STORMWATER COMPLIANCE INSPECTION REPORT

Name and Location of Site inspected A E Downs Enterprises 22227 76 th Ave S Kent, WA 98032-1924	GPS Entrance: Lat: N 47° Long: 122° 15.290' 25.937' Discharge: Lat: 47° Long: 122° 15.214' 25.917'	Entry Time 10:18	Permit Effective Date 1/14/2005
		Exit Time 10:55	Permit Expiration Date 9/20/2007
On-Site Representative(s): Name(s)/Title(s)/Contact number(s) or E-mail Jean Crocker- Secretary		Additional Participants: Jaron Smith- Ecology	
Responsible Official(s): Barbara Downs A E Downs Enterprises 22227 76 th Ave S Kent, WA 98032-1924 Phone: (253) 872-8147		Yes No Samples Taken? <input type="checkbox"/> <input checked="" type="checkbox"/> Photos Taken? <input checked="" type="checkbox"/> <input type="checkbox"/>

PHOTO ADDENDUM – A E DOWNS ENTERPRISES 5/16/2006

P5160039 DESCRIPTION: MORE WASTE BARRELS AND OPEN SAWDUST CONTAINERS

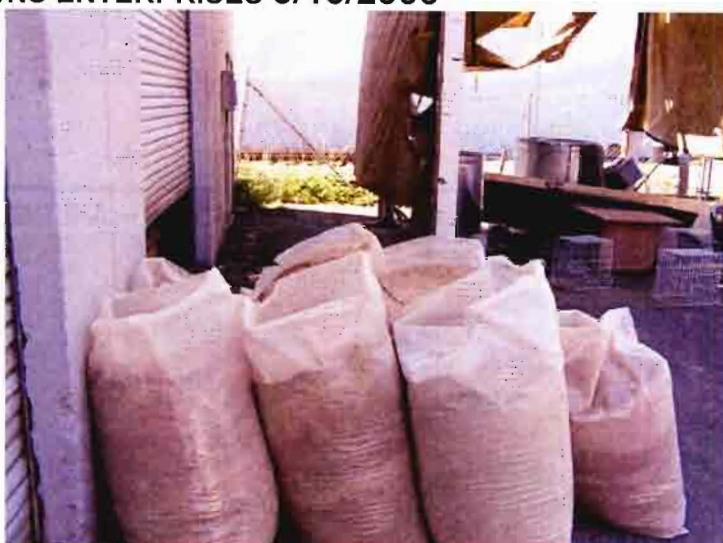
The exposed area on the west side of the building had two large dumpsters and numerous barrels full of wood debris, used paint cans, and other garbage (P5160038, P5160039 and P5160044). There was also a cart stacked with paint cans and two drums stacked on secondary containment crates in this area. The secondary containment crates are nearly full of stormwater and will not be effective at containing any chemical spills (P5160040 and P5160037). Secondary containment is

- Implement the necessary Best Management Practices (BMP) to prevent sawdust from polluting stormwater. Sawdust containers should be covered or sealed if stored outside or disposed of in uncovered dumpsters. Also, ensure that saw dust around the lot is swept up frequently and disposed of properly to reduce the potential to pollute stormwater.
